Notice No.6

Rules and Regulations for the Classification of Naval Ships, January 2022

Issue date: December 2022

9.3 Chain lockers

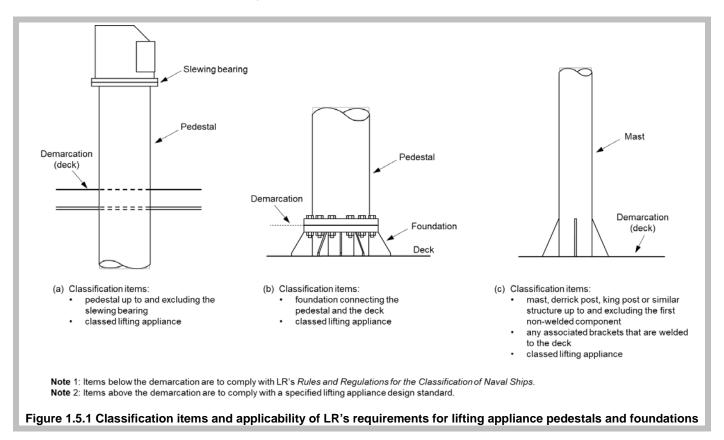
Existing sub-section 9.3 to be replaced with a new sub-Section 9.3 below:

9.3.1 Chain lockers and supporting structures shall be capable of withstanding loads associated with ship motions in the forward region acting on the anchor cable as a lumped mass, see Vol 1, Pt 5, Ch 3, 5.4 Loads for decks designed for cargo or heavy equipment loads, Pcd and Wcd.
